Access Compliance Report

Public Rights-of-Way

(Curb Ramps)

Intersection ID: 47876	Main Street: MARYANNA_CT	Cross Street: WOODSORREL_LN	Location: N
ADA ID: 27113903E506	Ramp Type: PerpDiag	Initial Pass/Fail: Fail	Overall Compliance: No
			Severity Score: 33.75

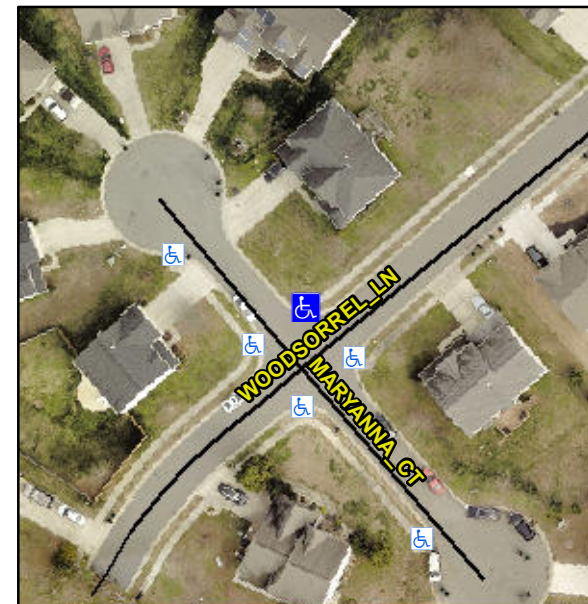
Not Found, R304.5.1, R304.5.3

Compliance	Description	Data	Compliance	Description	Data
N/A	Ramp Length (in)	48.0	Yes	Ramp Slope (%)	5.1
No	Ramp Width (in)	44.0	No	Ramp XSlope (%)	13.8
N/A	Flare Type LT	N/A	N/A	Flare Type RT	N/A
N/A	Flare Slope LT (%)	N/A	N/A	Flare Slope RT (%)	N/A
N/A	Flare Traversable LT?	N/A	N/A	Flare Traversable RT?	N/A
N/A	Landing Length (in)	N/A	N/A	DWS Provided?	N/A
N/A	Landing Width (in)	N/A	N/A	DWS Contrast?	N/A
N/A	Landing Slope (%)	N/A	N/A	DWS Length (in)	N/A
N/A	Landing X Slope (%)	N/A	N/A	DWS Full Width?	N/A
N/A	Landing Curb? (Y/N)	N/A	N/A	DWS Offset (in)	N/A
N/A	Shared Landing?	N/A			
N/A	Gutter Ponding?	N/A	N/A	Gutter Slope (%)	N/A
N/A	Gutter Lip Ht (in)	N/A	N/A	Gutter X Slope (%)	N/A
N/A	Painted X Walk1?	No	N/A	Painted X Walk2?	No
	X Walk 1 Direction	To SE		X Walk 2 Direction	To SW
N/A	X Walk 1 Width (in)	N/A	N/A	X Walk 2 Width (in)	N/A
	X Walk 1 Slope (%)	5.6		X Walk 2 Slope (%)	1.6
	X Walk 1 X Slope (%)	8.7		X Walk 2 X Slope (%)	8.1

Remove & Replace Curb Ramp With Two New Directional Ramps or Equivalent.
